BAR CASE # 2016-00342  
2016-00343

City Council  
January 28, 2017

**ISSUE:** Appeal of a decision of the Board of Architectural Review, Old & Historic Alexandria District, approving a Permit to Demolish and Certificate of Appropriateness

**LOCATION:** 317 South Lee Street

**FIGURE 2:** View from South Fairfax Street through private alley to rear of 317 South Lee; proposed addition to be approximately where red arrow is pointing behind the large trees.

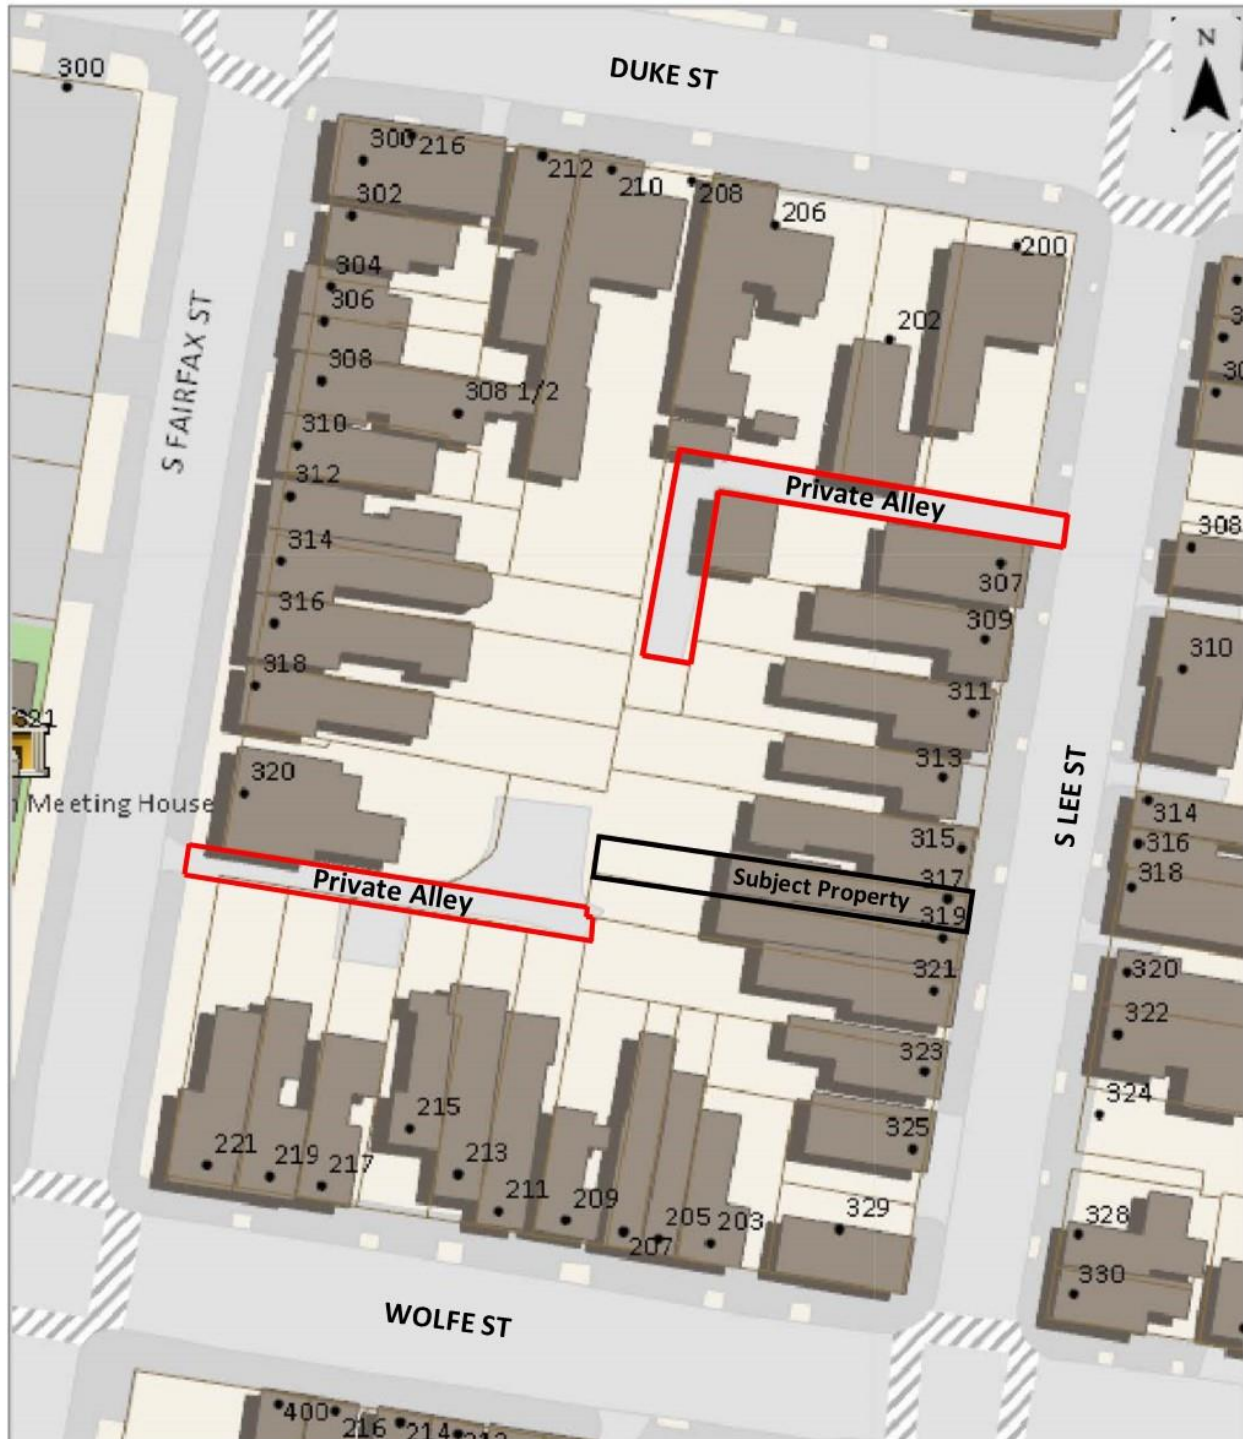
The BAR examines and determines the appropriateness of the height, mass and scale of a new building or an addition and considers how such a proposal fits within the historic district. In this particular case—for a second story addition on an existing one-story rear ell—the BAR considered the visibility of the proposal and how it fit into the existing context. The visibility of this rear addition is extremely limited and only a small portion is obliquely visible from South Fairfax Street through a private alley. From the photograph, the visibility of the proposed addition is nearly indiscernible. However staff notes that the BAR must assume that a project presently hidden by trees would be visible if those trees were to die in the future. Figure 1 shows the ownership of the alleys and Figure 2 shows the sight line through the interior of the block from which the rear addition would be visible if there were no trees.

FIGURE 3: 1902 Sanborn Insurance Map with annotations indicating the heights of different building elements in the where the subject property is located.

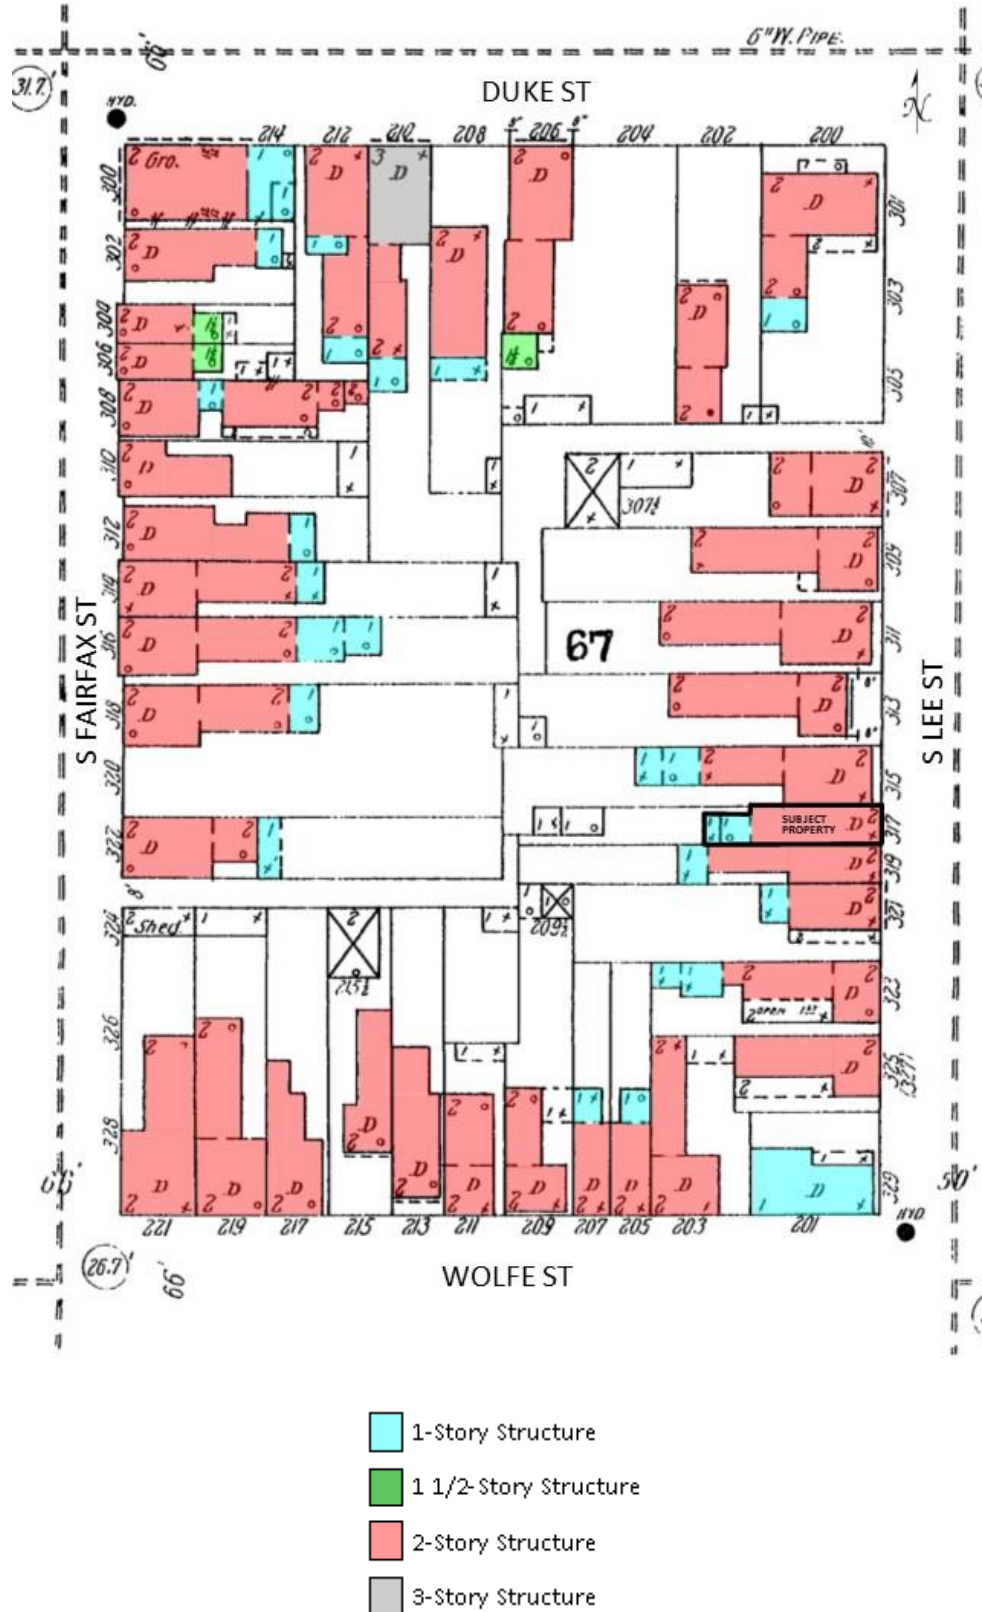
When considering whether the proposed height, scale and mass would fit within the existing context of the interior of this block, staff considered the height, scale and mass of the surrounding buildings. This block is predominantly comprised of townhouses of varying sizes. The height (in stories) of the majority of this block is two stories, which typically includes both the main block and the rear service wings or “ells”. These utilitarian ells extend into the rear yard and originally contained the less formal rooms of the house, including kitchens and secondary bedrooms. They were constructed at the same time as the main block but were frequently reconstructed or expanded over time. For the west side of the 300 block of South Lee Street, staff’s analysis of Sanborn Fire Insurance Maps from 1885-1958 indicates that all but three buildings have had two story rear ells since at least 1902 (see Figure 3). Staff’s research of BAR case files also indicates that the BAR approved eight rear additions, extensions or the enclosing of rear porches from 1966 to the present, including the one-story rear addition in 2011 at the subject property (see Figure 4).

Therefore, the historical research overwhelmingly illustrates that the predominant character of the residential dwellings on this particular block is for two-story buildings, particularly in the rear.
